DOCKETS 50-266 AND 50-301  
SUPPLEMENT 10 TO APPLICATION FOR AMENDMENT TO  
FACILITY OPERATING LICENSE APPENDIX A:  
TECHNICAL SPECIFICATIONS IMPROVEMENT PROJECT  
RESPONSE TO RAI ON ITS SECTION 3.7  
POINT BEACH NUCLEAR PLANT, UNITS 1 AND 2

DOCKETS 50-266 AND 50-301  
RESPONSE TO REQUEST FOR ADDITIONAL INFORMATION  
TECHNICAL SPECIFICATIONS IMPROVEMENT PROJECT SECTION 3.7  
POINT BEACH NUCLEAR PLANT UNITS 1 AND 2

Figure 3.7.12-1 (page 1 of 1)  
Fuel Assembly IFBA Requirements

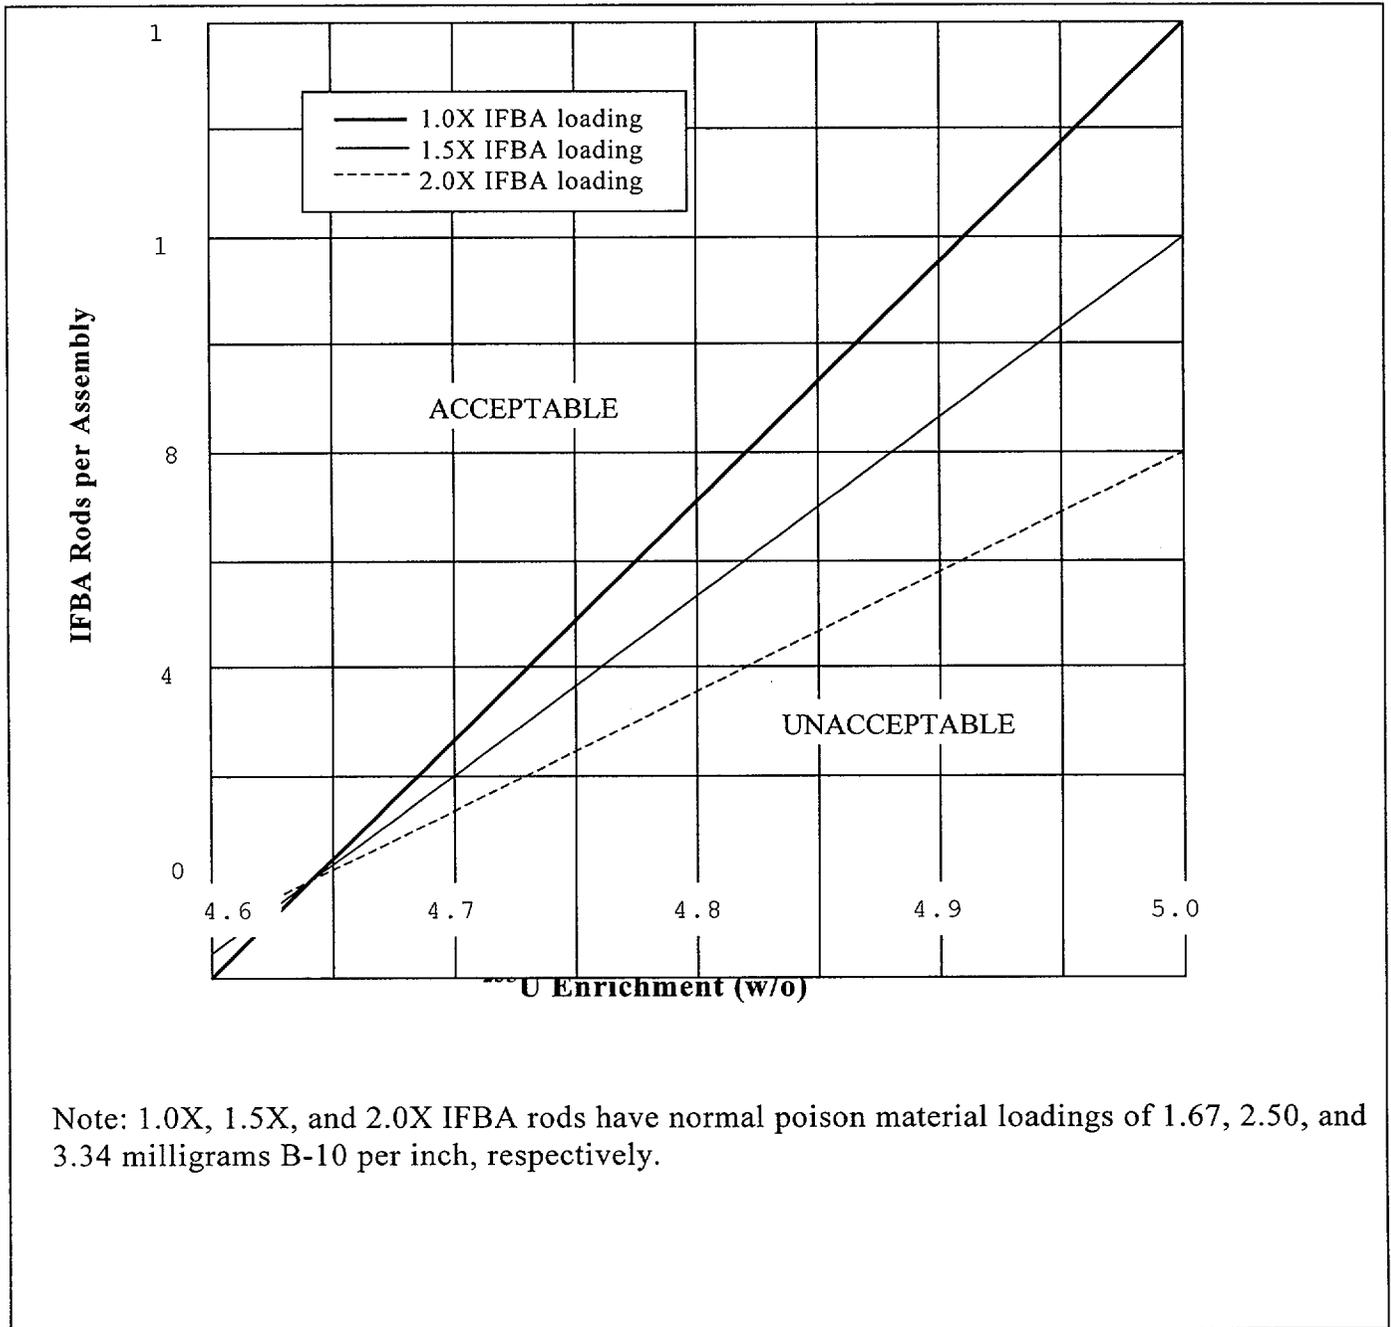
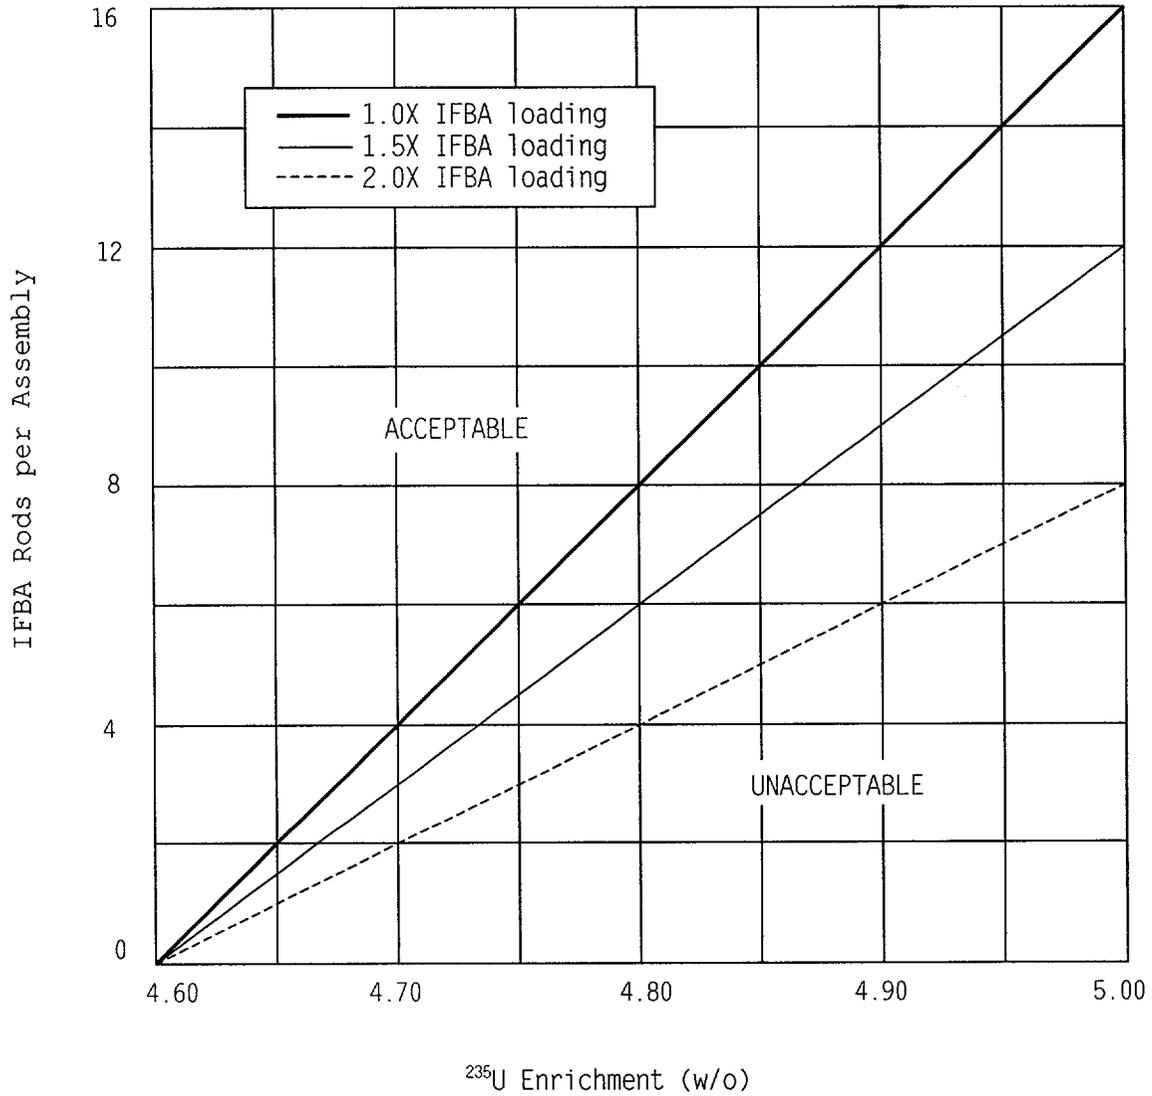
(3) The title from CTS Figure 15.5.4-1, "Fuel Assembly IFBA Requirements" must be retained for ITS Figure 3.7.12-1 because this figure only pertains to IFBA requirements and not to all "Fuel Assembly Storage Limits," as implied.

(3) The title for ITS Figure 3.7.12-1 has been changed to "Fuel Assembly IFBA Requirements." The revised title better describes the intent and limitations of the table and is consistent with the presentation of this information as it appears in the CTS.
